Road Safety Audit Stage 2

Westgate Road/ Sherborne Mini Roundabout

Report Title:	Westgate Road/ Sherborne Mini Roundabout Road Safety Audit Stage 2
Date:	16th November 2020
Document reference and revision:	JUB/20/19183/2/MM
Prepared by:	M & S Traffic
On behalf of:	West Sussex County Council

TITLE:
WESTGATE / SHERBORNE ROAD
MINI ROUNDABOUT
GENERAL ARRANGEMENT

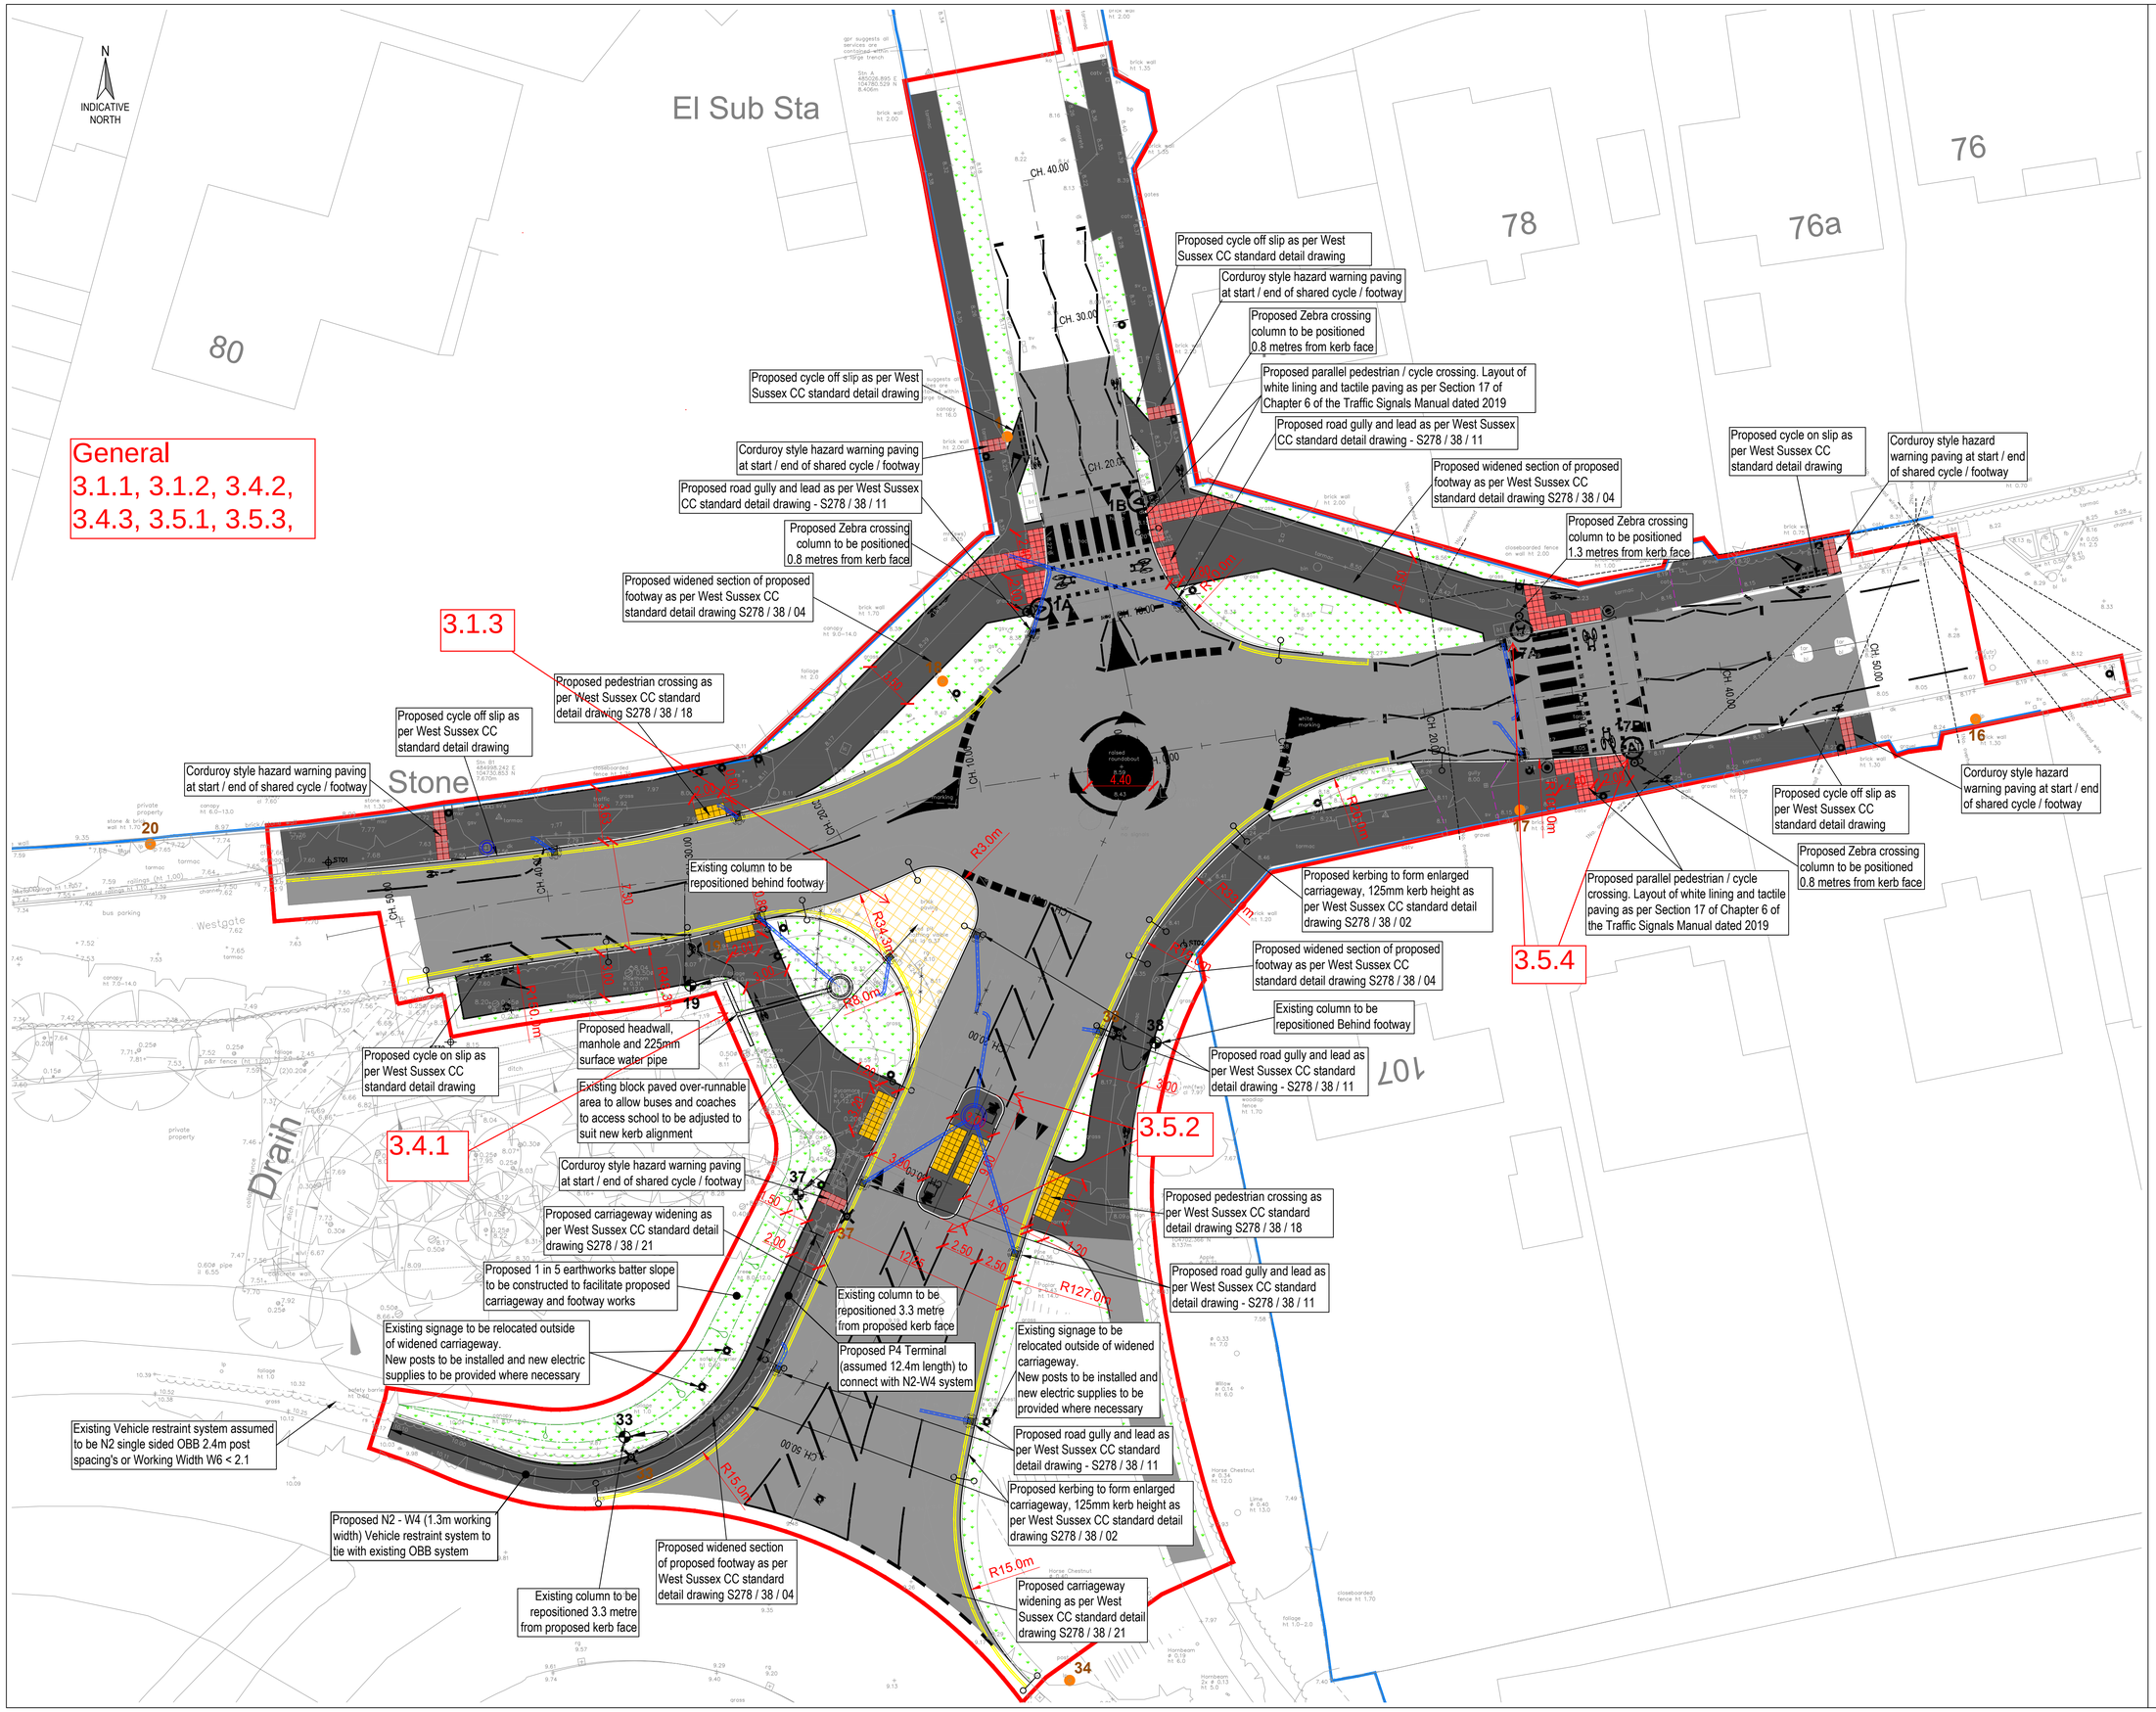
No details of the ramp profiles or height of raised carriageway have been provided for assessment. There is concern that if the height is outside normal ranges, this could lead loss of control collisions

The proposals do not include the introduction of anti-skid surfacing or a surface with a high Polished Stone Value (PSV). Surfacing with an inadequate PSV could lead to vehicles not being able to stop, leading to possible rear end shunt or vehicle to pedestrian collisions.

The proposals appear to show a 25mm kerb upstand and the relaying of the existing block paved surfacing. The Polished pavior value (PPV) of the block paving is unknown and surfaces with an inadequate PPV could lead to vehicles losing control when turning. Leading to collisions, vehicle overturning or load shifting.

The footway and cycleway traverse an open ditch, where no details of barriers to prevent pedestrian or cyclist incursion into the ditch particularly during the hours of darkness, have been shown, which could result in injury.

The tactile paving is shown as being red on the drawings supplied. Whilst it is recognised that this could be a drafting error, incorrect colour tactile paving could lead to visually impaired pedestrians misinterpreting the entry/exit points to the shared use areas., which could lead cyclist to pedestrian collisions.

Tactile paving is shown as being included in the designs, where this is not required at cycle crossing points. The use of inappropriate tactile paving could lead to visually impaired pedestrians being confused and could lead to could lead cyclist to pedestrian collisions.

Give way lines appear to be too close to the stud lines on one of the approaches at each crossing. This may cause vehicles to stop at inappropriate locations and may also reduce the intervisibility with pedestrians who are crossing, particularly child pedestrians, which could lead to vehicle to pedestrian or rear end shunt collisions.

On approaches to the pedestrian refuge, the hatch markings lead traffic into the island, which may lead to kerb strikes and loss of control collisions.

On the to the ramped Tiger crossings humped signage is shown rather than humped crossing signage. This could lead to possible driver confusion could lead to loss of control or vehicle to pedestrian or cyclist collisions.

Belisha beacons are shown as being on the exit sides of the crossing, this could lead to parts of the beacons being masked by waiting pedestrians and reducing the conspicuousness of the crossing. This could lead to possible driver confusion and could lead to rear end shunt or pedestrian or cyclist collisions.

It is recommended that ramp profiles should be within normal accepted ranges.

It is recommended that high friction surfacing should be provided on the approaches to the crossings and continue to the crossing carpets.

It is recommended that the PPV should be similar to the PSV of the surrounding carriageway areas and adequate for the speed of the road.

It is recommended that fencing should be provided and that details should be supplied for assessment.

It is recommended that the tactile paving should be buff in accordance with Department for Transport guidelines.

It is recommended that the tactile paving should be removed.

It is recommended that the Give way markings should be set back a minimum of 2.5m from the stud lines.

It is recommended that the hatch markings should be altered so there is at least 150mm clearance between the road markings and island.

It is recommended that the appropriate signage is installed showing both the humped crossing and parallel crossing.

It is recommended that the belisha beacons should be positioned on the approaches to the crossing
